waterfront
SEATTLE

BELL STREET

概念设计反馈意见摘要

2023 三月

概念选项 1: 空间

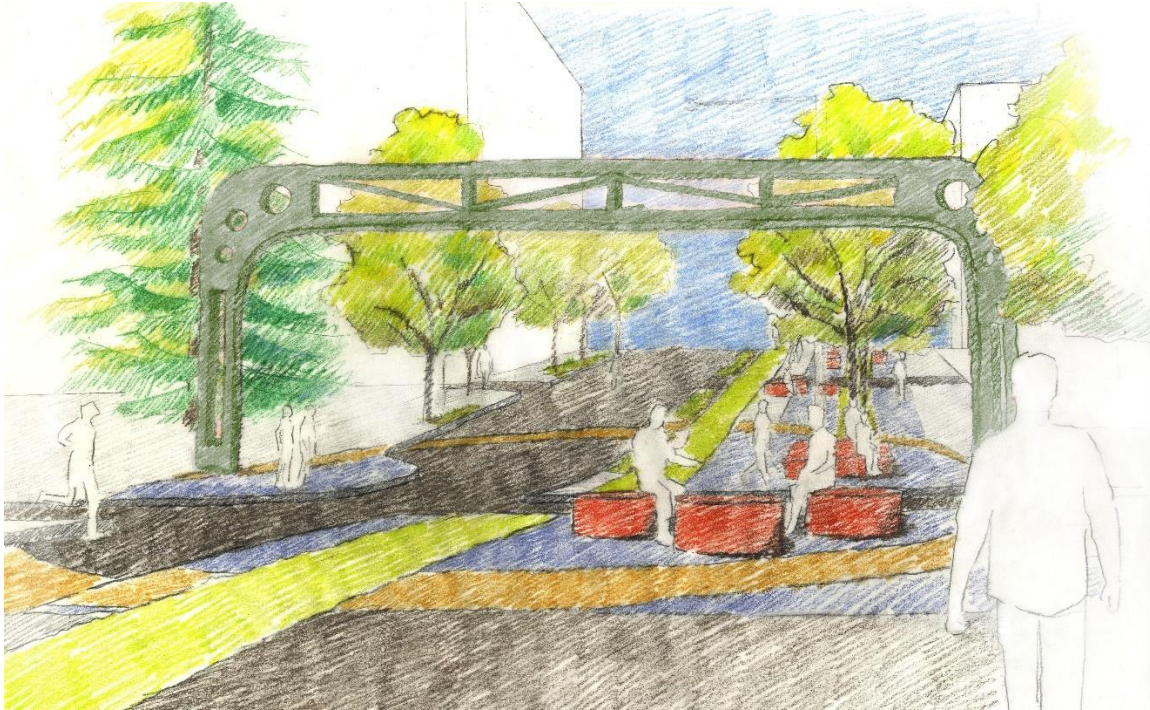
在外联的第一阶段，受访者明显希望 Bell St 的这个路段有一条专门的自行车道。早期概念设计中提出了两个版本，一种是带有分隔自行车道与机动车道的植物缓冲带的共用自行车道，另一种是双向自行车道。略高于 60% 的受访者倾向于双向自行车道。

一些受访者强烈建议避免共用车道标记，许多人支持在双向自行车道选择中，自行车道和机动车道之间设置持续的结构性缓冲。一条意见指出，植物缓冲带没有给人一种与机动车道充分分隔的感觉。

- “自行车道必须连续（没有让人在街道上骑行的缺口），并用混凝土/花盆/路桩作为缓冲。”

- “我更喜欢双向自行车道，这至少提供了两个人或一名成人和一名儿童在某些情况下并排骑行的选择。这是骑行的社交方面，西雅图几乎所有道路都严格限制骑行者并排骑行！”
- “自行车道应该足够宽，以允许快速下坡的自行车轻松地经过上坡的自行车。”
- “双向自行车道的面积应该扩大一倍。自行车空间的分配仅取决于空间/速度，而机动车空间的分配极大地取决于汽车。”
- “我会提出一个更激进的概念方案：将 Western Ave 和 1st Ave 之间的 Bell St 对汽车关闭，把柏油路换成更容易上坡的蜿蜒自行车道，就像针对 Pike Pl 和 1st Ave 之间的 Pine St 的计划一样。”Belltown 值得拥有自己的 Lombard St，但不能被汽车玷污。”
- “让骑行变得有趣和安全，让我的爸爸可以骑着电动自行车带孙子到处走”
- “我倾向于把 Bell Street 变成真正的‘自行车大道’，让骑行者优先于驾驶者。”
- “我希望人行道和自行车道之间有立交桥。”
- “如果增加减速带，请为自行车留出缺口。”

概念选项 2：口袋花园

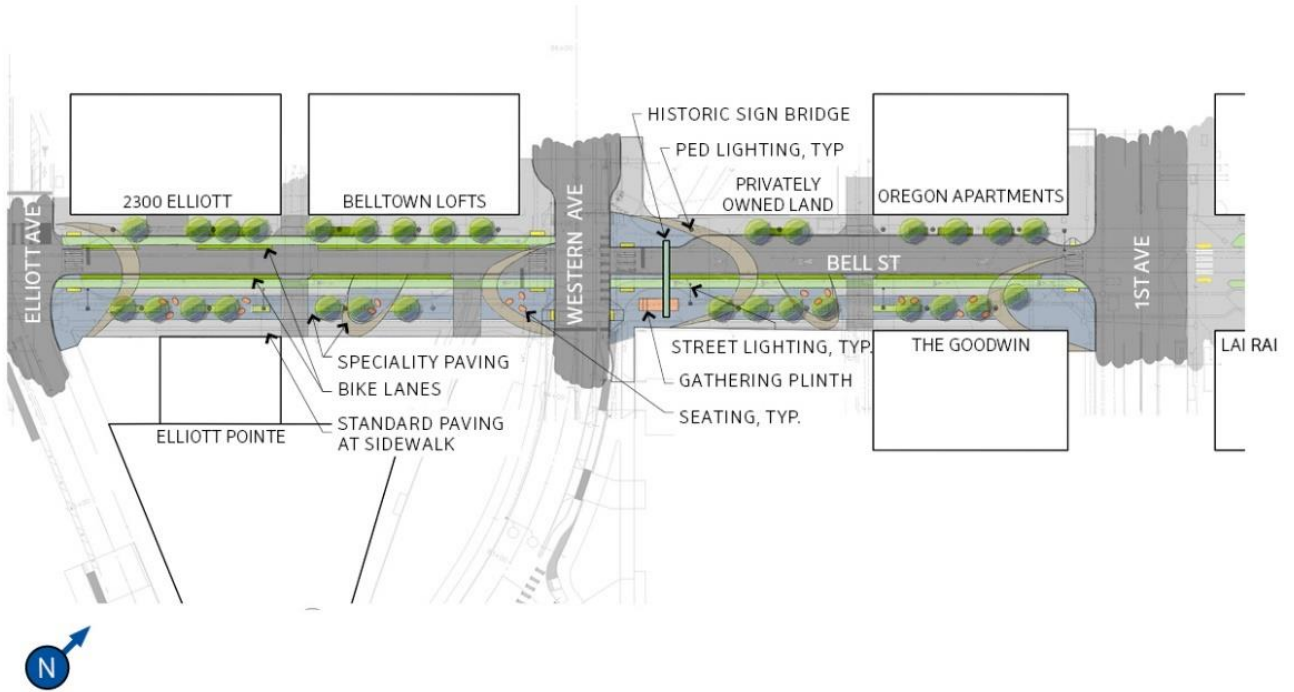
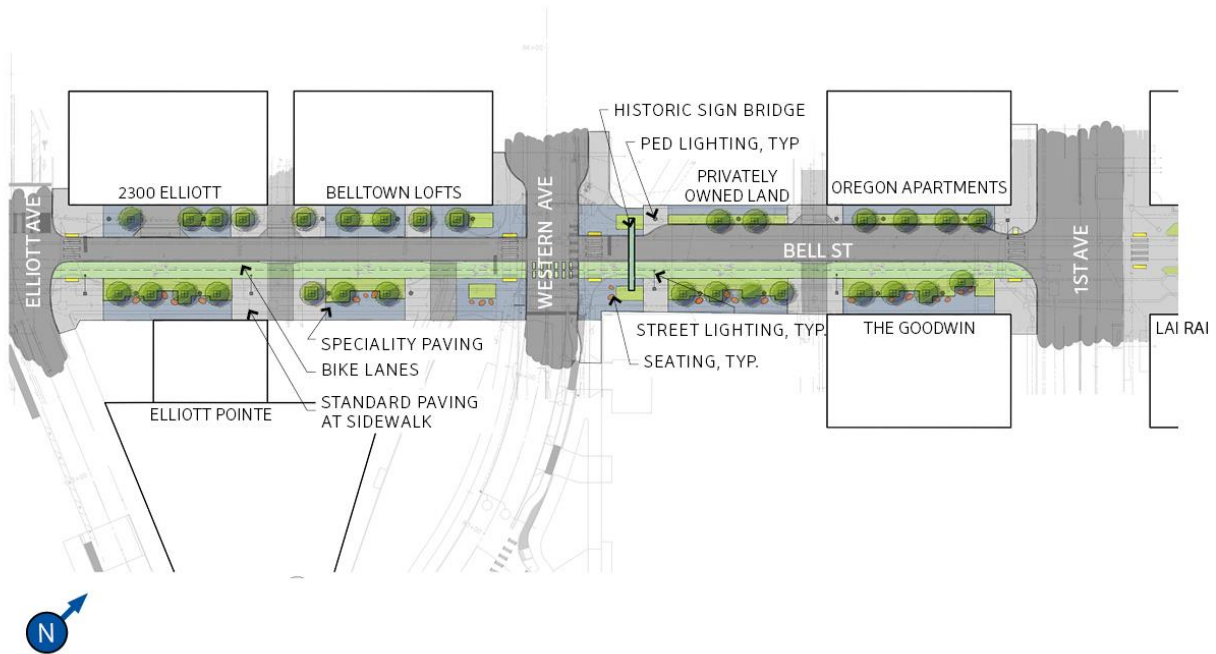
Please consider option 2. A two way protected bike lane would be a great addition to the neighborhood. Increased greenery would create a lush entrance to the new waterfront promenade.

I like Concept Option 2 very much, and if it's possible to add any more plantings to it that would be even better.

not sure such a generous two-way bike lane is needed for this stretch of road. work in some of the curved/arc'd elements of option 1 into option 2, which i believe provides a more generous and intuitive pedestrian experience than option 1 albeit being a bit blocky. hopefully surrendering some of the 2 way bike path width from option 2 to additional pedestrian or planted space will give opportunity to bring in some of the curved or arc'd touches from option 1 into option 2.
